# SCHWEIZER SERVICE BULLETIN

C1B-030  
24 Aug 2010

**SUBJECT:** CENTER CONTROL COVER CONTACTING LATERAL CYCLIC CONTROL ROD

**MODELS AFFECTED:** • 269C-1 Model Helicopters Serial Numbers 0001 - 0371

Figure C1B-030-1. Control Cover Modification

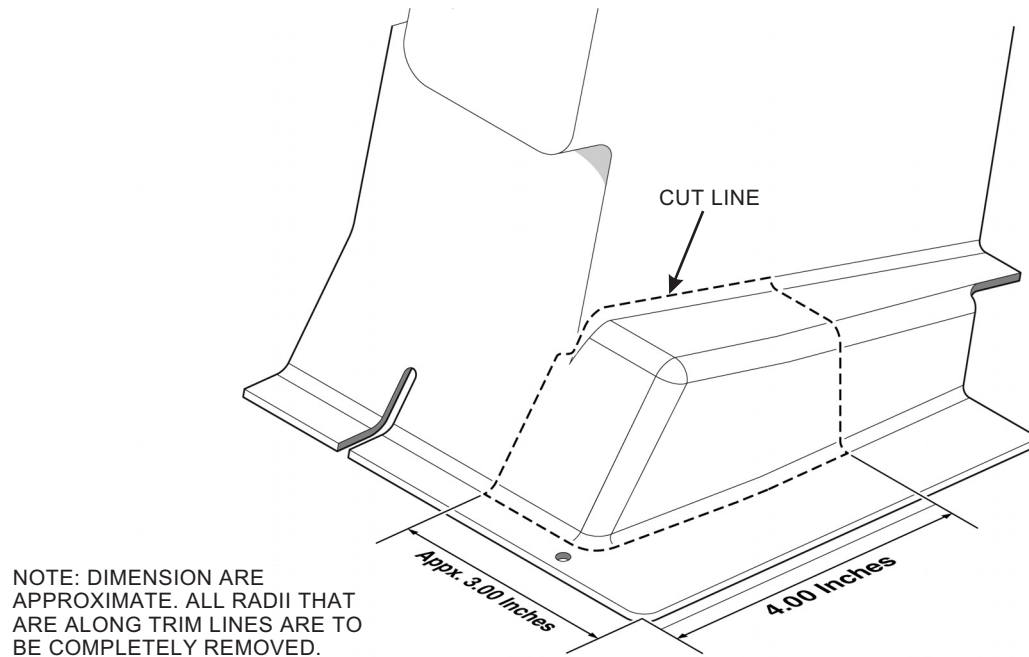
- b. Trim along CUT LINE as shown in Figure C1B-030-1 and remove section. Place patch over opening and against cover as shown in Figure C1B-030-2. Check for flat fit on all contact surfaces and trim as necessary for proper fit. While trimming, assure a minimum of .50 inch bend area overlap exists.
- c. Using 180 grit sand paper, rough all contact surfaces of patch and center cover in bond areas.
- d. Thoroughly clean bond area with Naptha or Alcohol and air dry for 15 minutes.

Figure C1B-030-2. Patch Installation

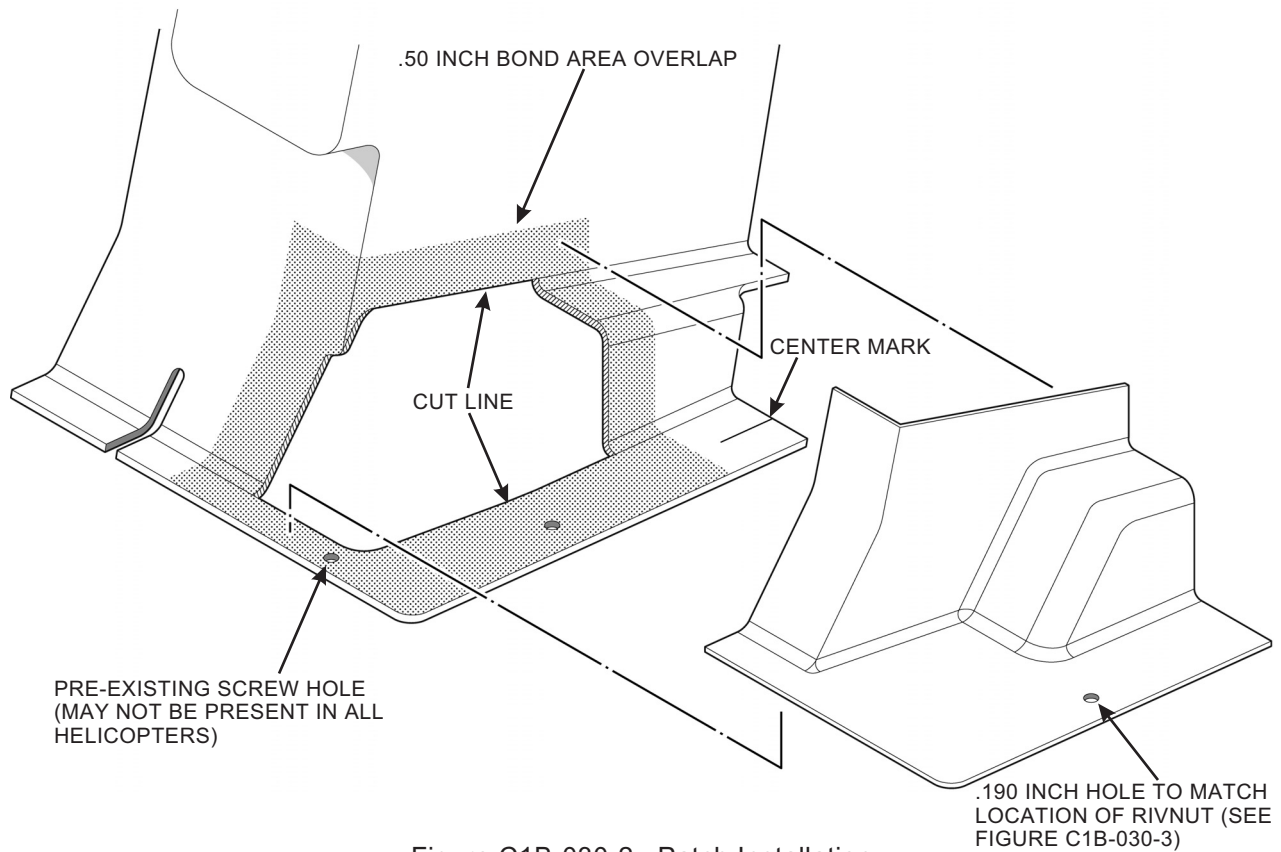
The patch is installed over the opening from the exterior of the cover and should fit flat on all contact surfaces. After insertion, an outline can be drawn around the edge of the patch to note the area covered. A minimum of .50 inch patch overlap is required around the perimeter of the opening. For proper fit of all edges, material can be removed from the cover up to the .50 inch limit (See Figure C1B-030-2).

- e. Apply a bead of adhesive (or sealing compound) to bonding surfaces and install patch. Press patch securely against cover and allow adhesive to cure over time period recommended by adhesive manufacturer's (Figure C1B-030-2).

- f. After adhesive (or sealing compound) is cured, trim excess material around edges as required and back drill pre-existing screw hole in flange (Figure C1B-030-2).

- i. Place a center mark on aft edge of cover flange as shown in Figure C1B-030-2. Place center cover in position and align center mark on flange with seat belt bracket. With cover held in position and using a hole finder centered on Rivnut, drill a .190 inch hole in cover flange.

Figure C1B-030-3. Rivnut Installation

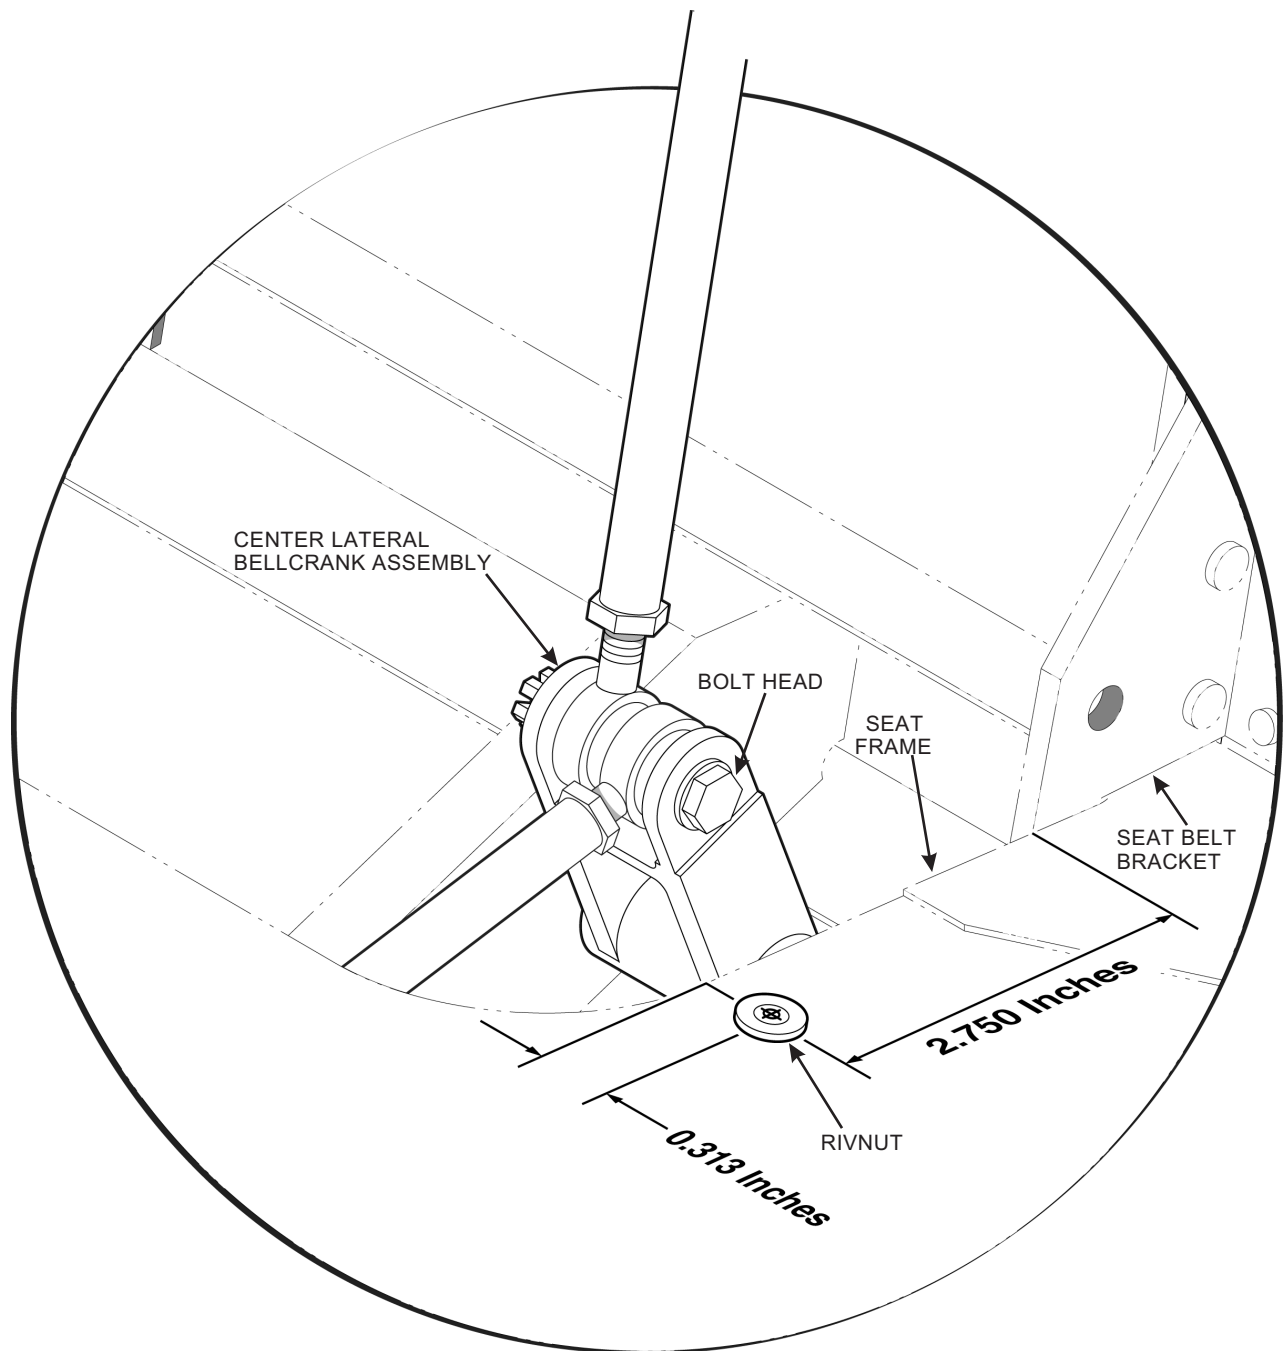
- h. Drill a .250 inch hole in seat frame in location 2.75 inch forward from seat belt bracket and .313 inch outboard from edge of seat frame as shown in Figure C1B-030-3 and install a NAS1329S3K80 Rivnut.
